TECHNICAL BULLETIN

206-17-210

MODEL AFFECTED: 206A/B and TH-67

SUBJECT: LINEAR ACTUATOR ELECTRICAL CONNECTOR
COVER DAMAGE LIMITS AND REPAIR
INSTRUCTIONS, INTRODUCTION OF

Figure 1 - Linear Actuator

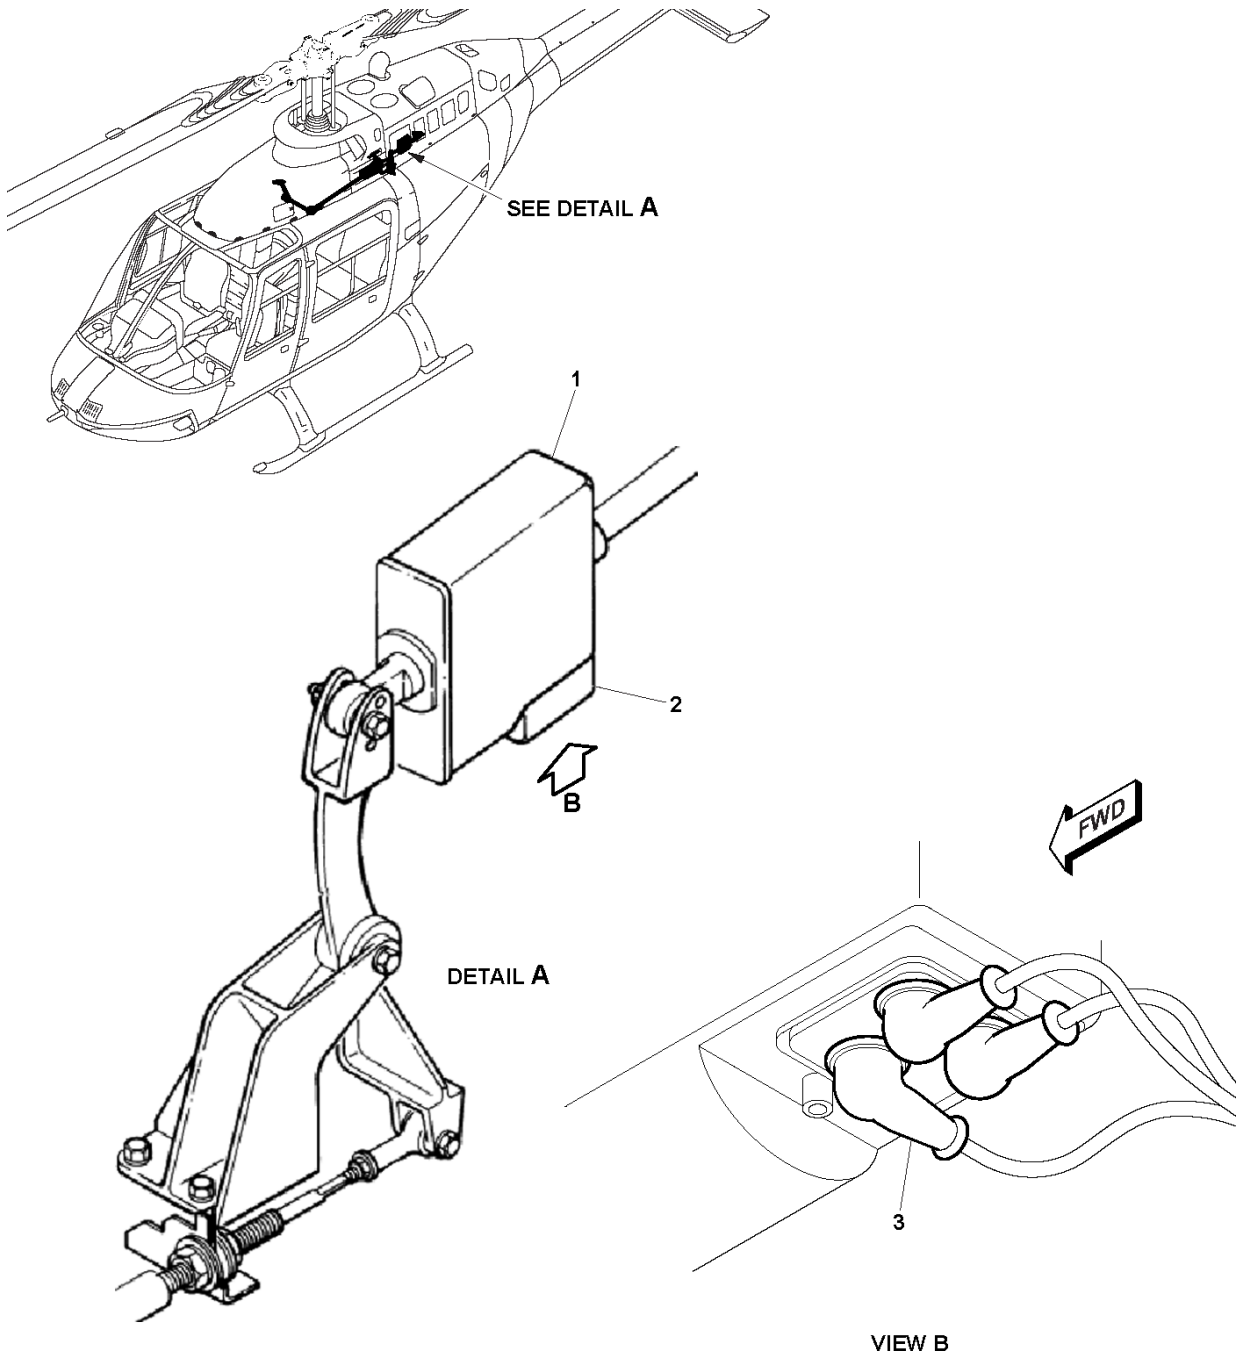
1. Prepare the helicopter for maintenance.
2. Inspect linear actuator connector cover (Figure 1, 2) for condition and security.
 - a. Cracks emanating from the attachment point screw area are not acceptable, and requires replacement of the connector cover (2).
 - b. Cracks not emanating from the attachment point screw area are acceptable, however, must be stopped drilled to prevent propagation.
 - c. Damage to the connector cover (2) that exposes the wire terminals is not acceptable, and requires replacement of the connector cover (2).

- d. Any other damage not affecting the security of attachment of the connector cover (2) or exposing the wire terminals are acceptable.
3. If a serviceable linear actuator connector cover (2) is not available as a replacement part, remove the cover (2) and install nipples 90-115-1 (3) on the three electrical connectors.
 - a. Remove the cover and disconnect the actuator electrical terminals one at a time to prevent mixing the cables.
 - b. Install a protective nipple 90-115-1 (3) on each terminal.
 - c. Reconnect terminals and move the protective nipple (3) into position over the attachment studs.
 4. Make an entry in the helicopter logbook and historical service records indicating compliance with this Technical Bulletin.
